BHP Pilbara Strategic Assessment

Validation Notice

Newman Hub Western Ridge

20 September 2023

Date:	12/09/2023	Project No:	A979/168C	Figure:	1-2
Prepared:	M. English	Checked:	A. Edgar

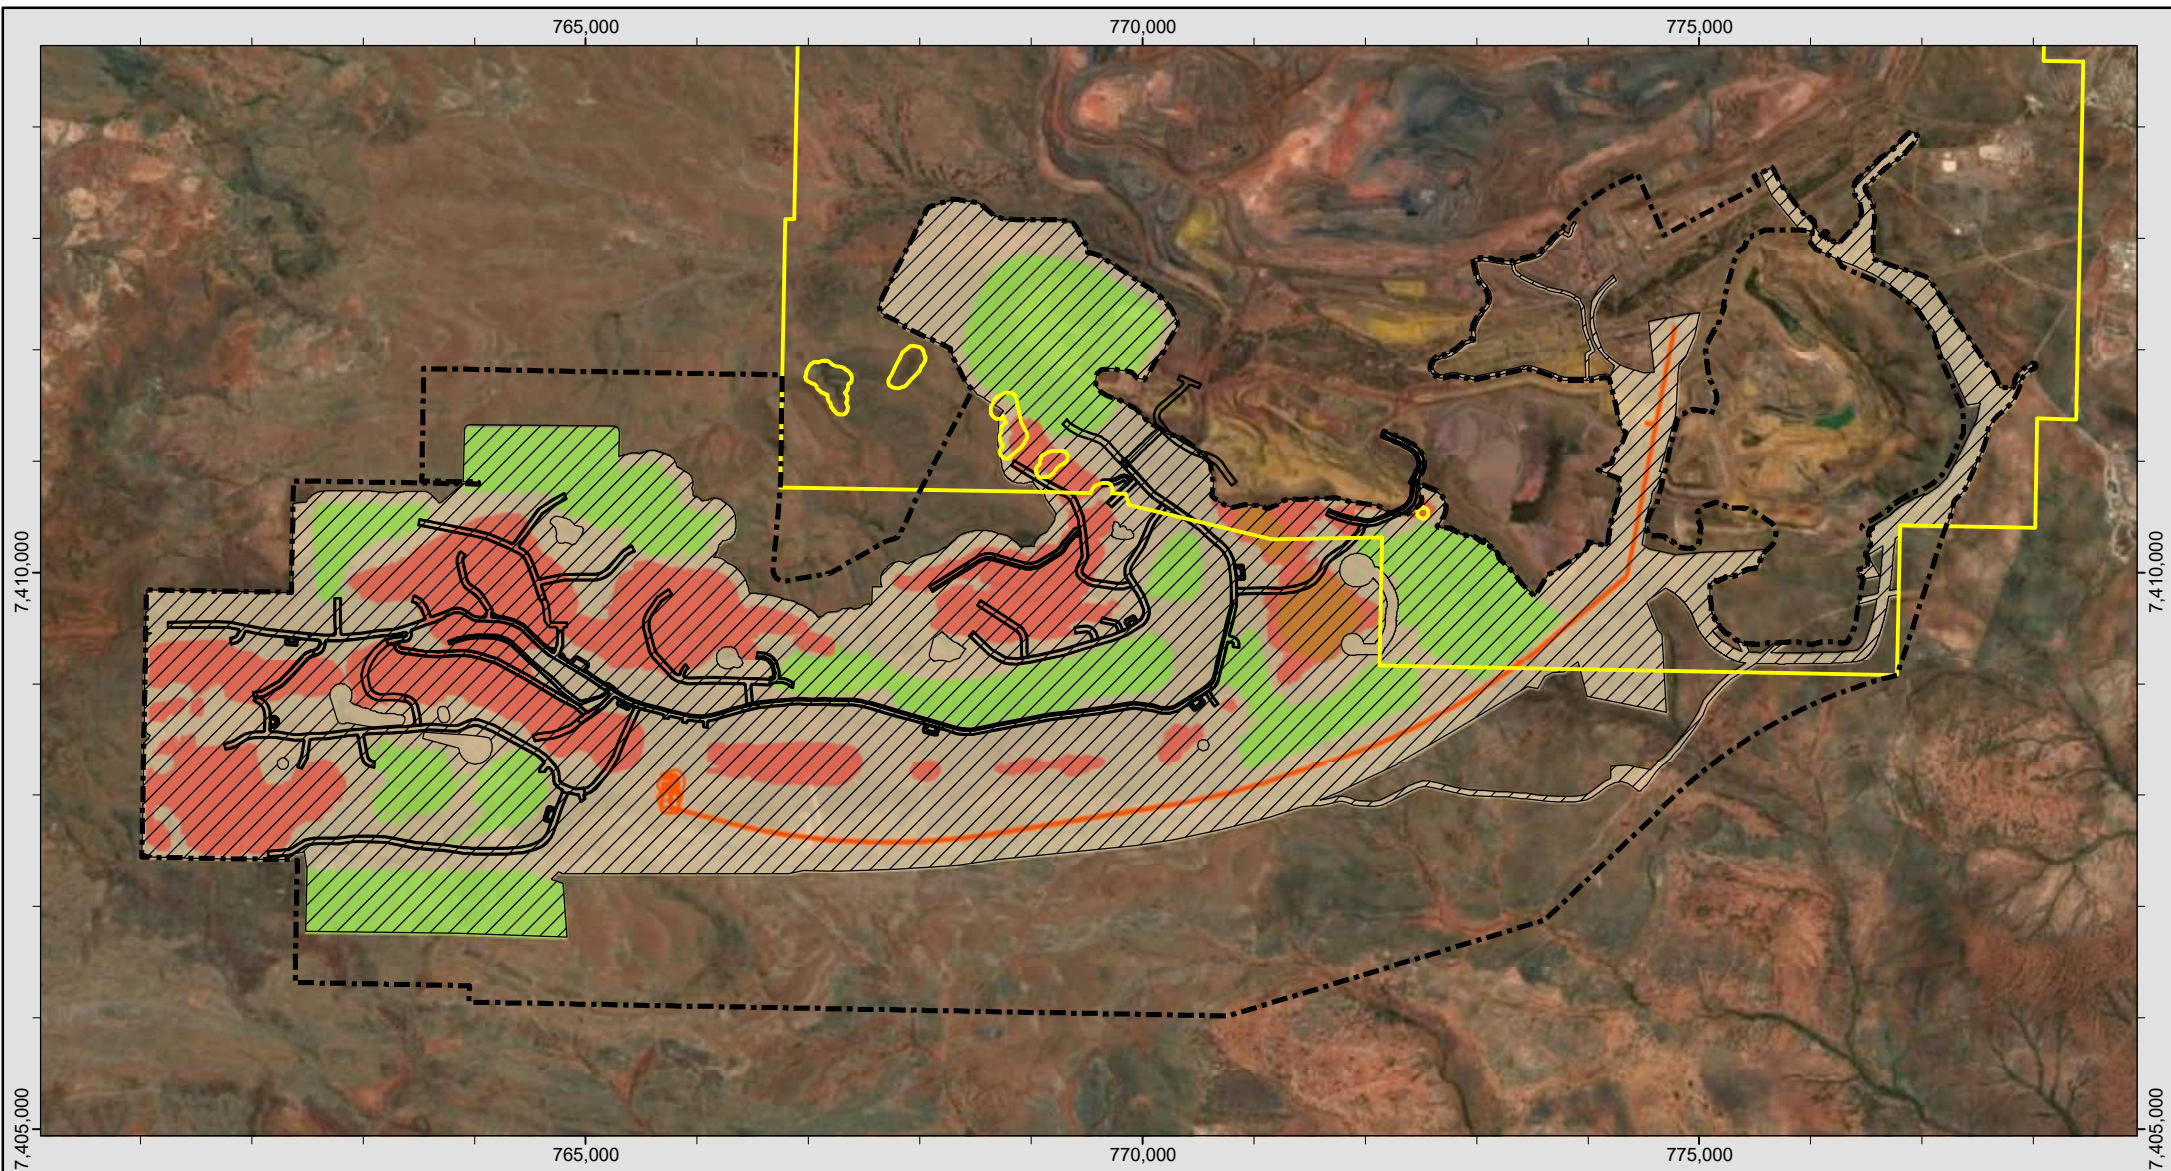
1.3 Figure 1.2 (p.6) refers to 'waste dumps'. In the list of what the Western Ridge Project will include (p.15) waste dumps are not listed. Are the 'waste dumps' the overburden storage areas, ore stockpiles and topsoil stockpiles listed on page 15? We recommended keeping terminology consistent in figures and text so it is clear to the reader what is being referred to in the Draft Validation Notice.	Text modified in Section 1.4 to state: overburden storage areas (also known as waste dumps).

1.4 Not all actions/areas of disturbance listed in section 2.2 (p.15) are shown in Figure 1.2 (p.6) or described in enough detail to assist the reader to identify potential impacts to program matters (e.g. what is the power supply and where will it be located?).	Figure 1.2 identifies the key components including pits, overburden storage areas (also known as waste dumps), conveyor and crusher and haul roads. Other supporting infrastructure is subject to variation in the final design phase and clearing will not exceed

4.4.9 Figure 1.2 (p.6) indicates that the Mining Exclusion Zones will be surrounded by the indicative footprint. It also indicates that 'waste dumps' (assumed to be overburden storage areas, ore stockpiles and topsoil stockpiles listed on page 15) will be located to the east and south of CWER-03 and CWER-10 and to the south of CWER-01, CWER-09 and CWER-17. Is there a designated maximum height for these waste dumps? The development of these waste dumps may cause Ghost Bats to change their established flight routes from the cave entrance to access foraging habitat or they may be unwilling to fly across these areas. We note the impact assessment includes the statement (p.52) 'Ghost Bats are highly mobile and able to fly over and around infrastructure'. Is there a reference or evidence to support this information?	BHP has not defined final overburden storage area (OSA) height. The OSAs will be designed in-line with the agreed post closure land use, provisionally "<i>Natural environment for managed resource protection or relatively natural environment for pastoral grazing purposes</i>", and in accordance with Mines Closure Design Guidance Procedure 0128030 and Rehabilitation Standard 0001074. Within the MCP the creation of fauna habitat as part of the Western Ridge Closure strategy is discussed. Consideration of undisturbed habitat will be incorporated into the final OSA designs. Ghost Bats are known to fly long distances to forage and traverse topographies naturally ranging from areas with high elevation with steep gorges to low flat plains. Overburden storage areas are not considered to present obstacles to movement any greater than existing landforms in the area.

4.4.11 As the overland conveyer is situated along the southern portion of the Activity Area and below Ghost Bat caves (Figure 1.2 p.6), has the need for deflectors been considered to mitigate potential Ghost Bat collision if they are flying at low elevation?	The overland conveyor is located approx. 1.6km from both Category 2 caves. The nearest cave to the overland conveyor is a Category 4 cave located approximately 480m from the conveyor. This cave has recorded old scats, with no recent activity detected. The conveyor will generate noise which may act as a deterrent. Collision of Ghost Bats with fences (especially those with barbed wire) is recognised as a direct threat in the species conservation advice (TSSC 2016). However, collision with other infrastructure is not listed as a threat. Bat deflectors are considered effective at deterring bat interaction with fences as they increase the visibility of the fence and deter bats from approaching or landing, due to either reflecting light and/or moving in the wind. The overland conveyor will be a solid structure and therefore is expected to be much more 'visible' to Ghost Bats, when compared to wire fences.

Date: 12/09/2023	Project No: A979/191C	Figure: 4-1
Prepared: SPATIAL DATA	Checked: ENV APPROVALS

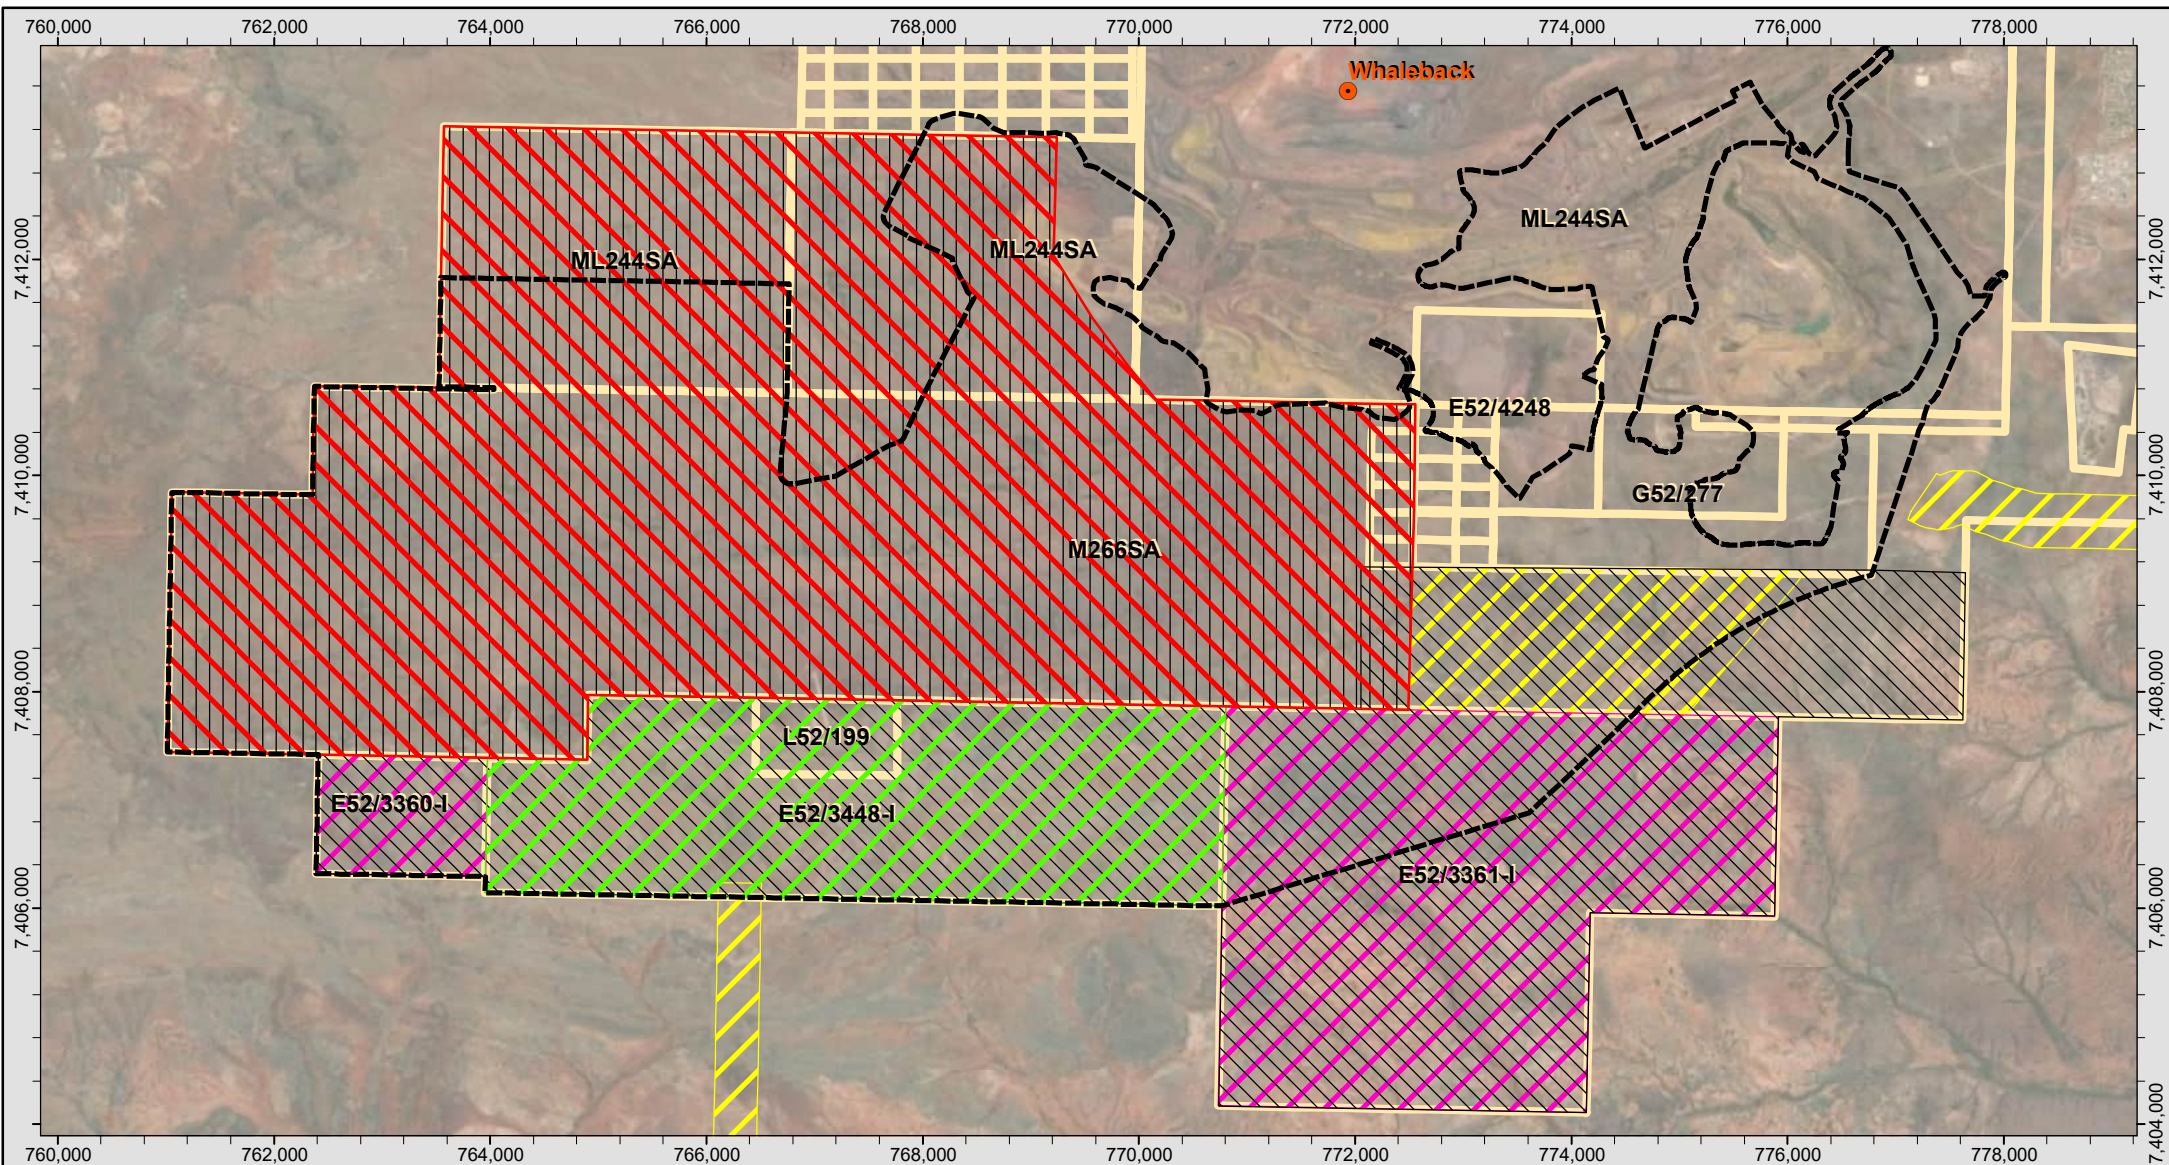
4.2.4 Hydrological reports (see comment at 2.3)	Noted
Northern Quoll	Northern Quoll 4.3.1 According to Figure 4.1 (p.27) the extent of the survey coverage area for the Northern Quoll does not appear to have surveyed a 500 m buffer to the west and south-west of the Activity Area boundary (other than a small section as part of the Western Ridge Pipeline Vertebrate Fauna Survey (Biologic 2022)).	Biodiversity surveys for Northern Quoll were predominantly within BHP's tenure boundaries with the exception of the pipelines survey.
Ghost Bat	4.3.1 A 'short-range endemic fauna avoidance zone' (see Figures 4.10, 4.11 and 4.16) is referred to as an avoidance measure (p.40). This is not identified by this term on the figures referenced. What does this refer to?	The Validation Notice depicts the avoidance zones applied to MNES as they are relevant to the Validation Notice; however, it only refers to the Short-range endemic (SRE) avoidance zone in text as this is not relevant to the Validation Notice. The SRE avoidance zone refers to areas that have been clipped out of the Activity Area to preserve habitat for SRE invertebrate fauna.

4.6.2 According to Figure 4.1 (p.27) the extent of the survey coverage area for the Pilbara Leaf-nosed Bat does not appear to have surveyed a 500 m buffer to the west and south-west of the Activity Area boundary ((other than a small section as part of the Western Ridge Pipeline Vertebrate Fauna Survey (Biologic 2022)).	Biodiversity surveys were predominantly undertaken within BHP's tenure boundaries with the exception of the pipelines survey, due to access constraints.

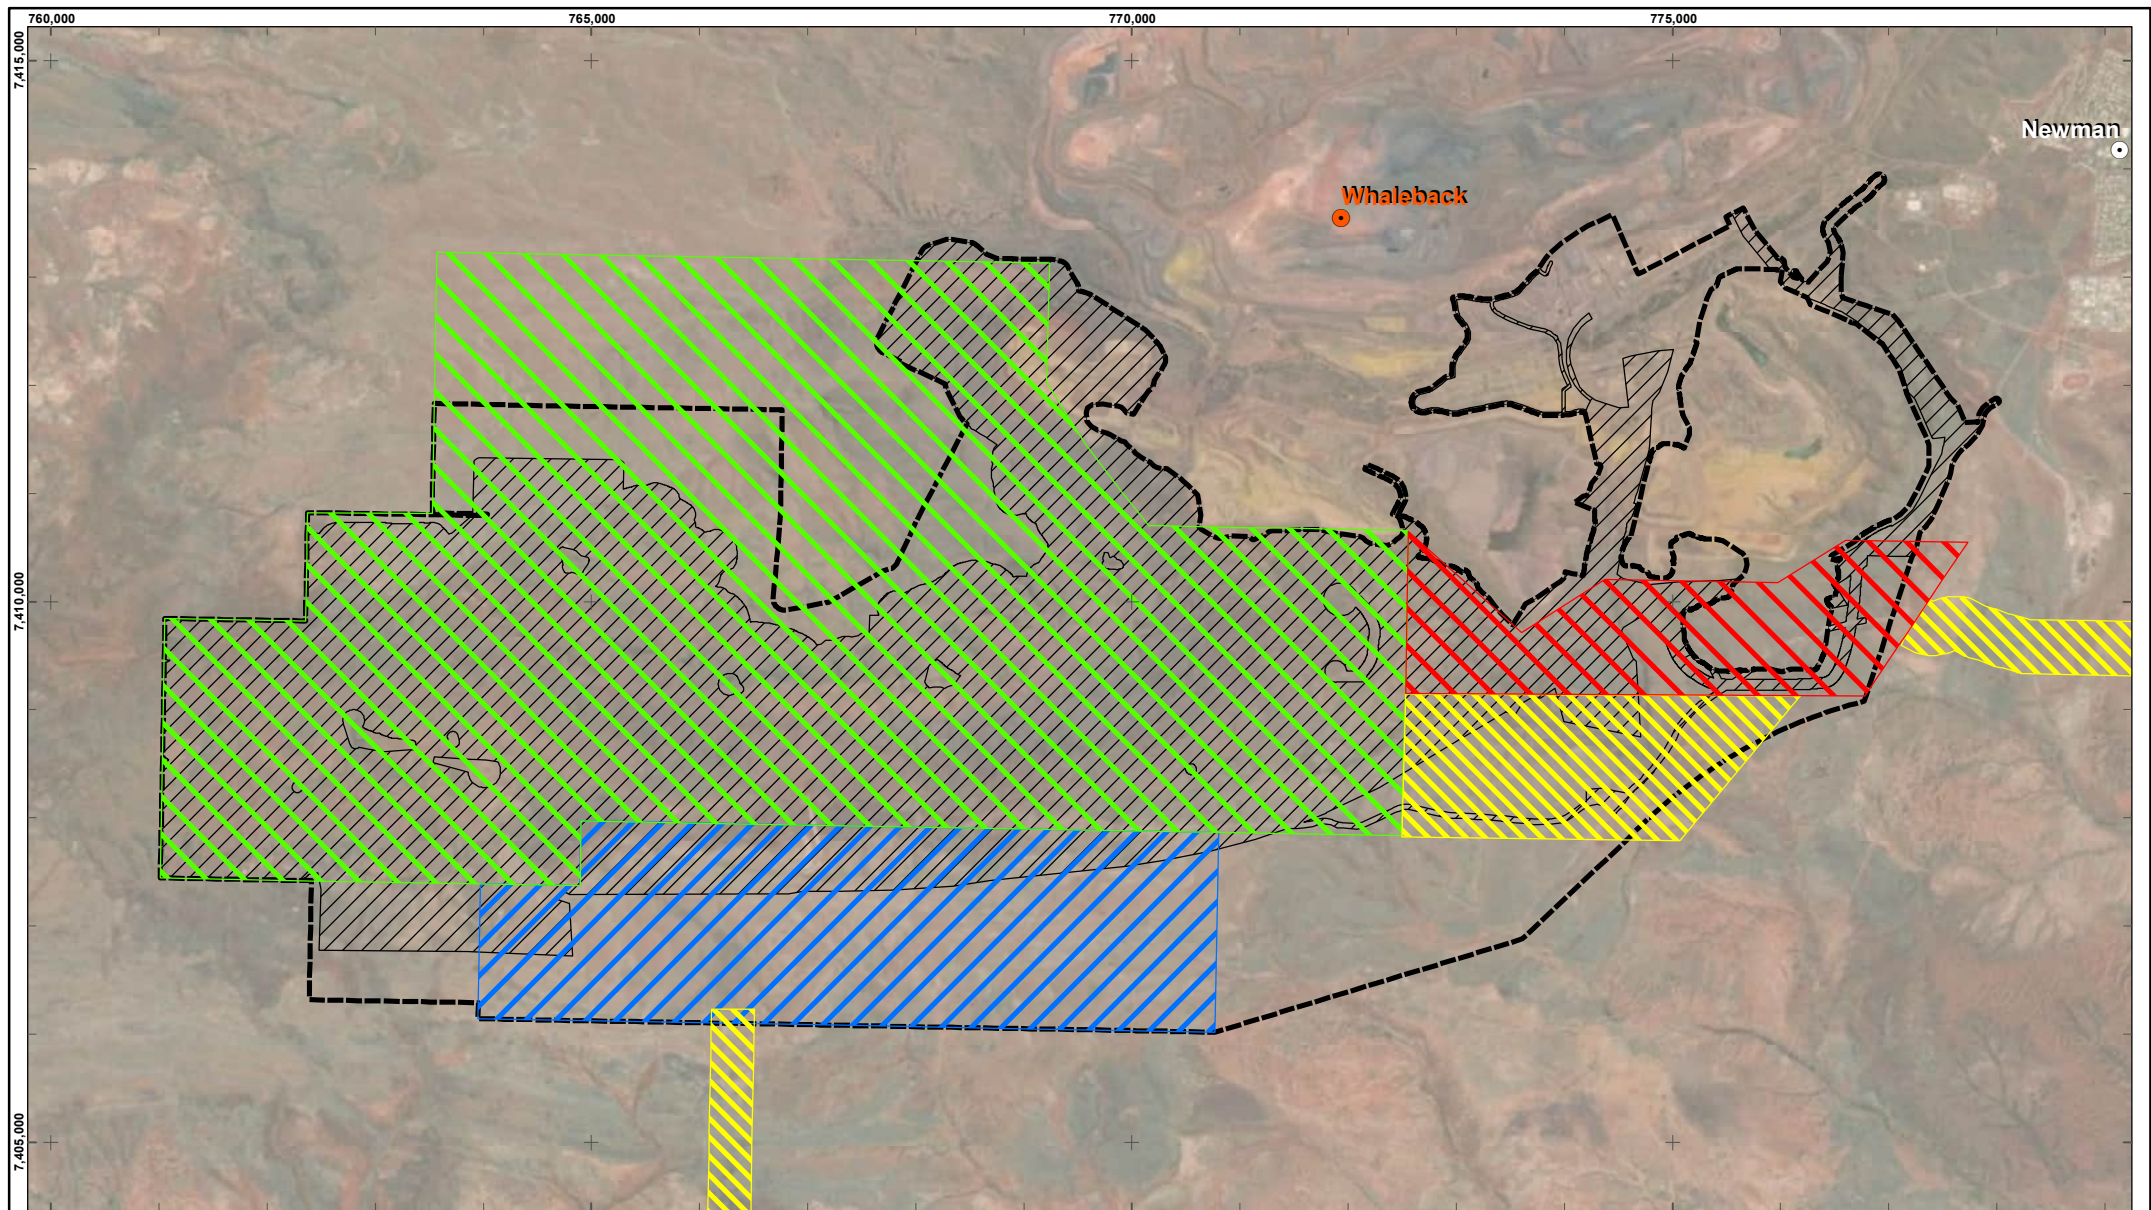
Grey Falcon	4.9.1 Figure 4-24 (p.97) refers to Grey Falcon survey areas from four surveys: - Western Ridge Targeted Vertebrate Fauna Survey (Biologic 2020) – only reference to the Grey Falcon is the species inclusion under Other Fauna of Conservation Significance in Table 3.9 (p.68) titled 'Species of conservation significance with the potential to occur in the Study Area'. Program Matters targeted in this survey were the Northern Quoll, Greater Bilby, Pilbara Leaf-nosed Bat, Ghost Bat, Night Parrot and the Pilbara Olive Python. - Western Ridge Pipelines Vertebrate Fauna Survey (Biologic 2022) – while no Grey Falcon was recorded during the survey it was listed as possibly occurring 'as an infrequent visitor and may forage in the Major Drainage Line and Medium Drainage Line habitats occurring within the Study Area'. No suitable nesting habitat was recorded within the Study Area. This survey area was small. - Western Ridge E52/3448 Desktop Flora and Fauna Assessment (Onshore Environmental 2018) – only reference to the Grey Falcon is a table stating that suitable habitat was present but that the species was unlikely to occur in the study area. The fourth survey: Western Ridge Paddy Bore Area Reconnaissance Flora and Vegetation Survey (Biologic 2022), does not appear to be included as an Appendix to the Draft Validation Notice and is not in the reference list. Please include a copy of this survey as an Appendix	The Western Ridge Paddy's Bore Area Vertebrate Fauna survey is included in Appendix 2.
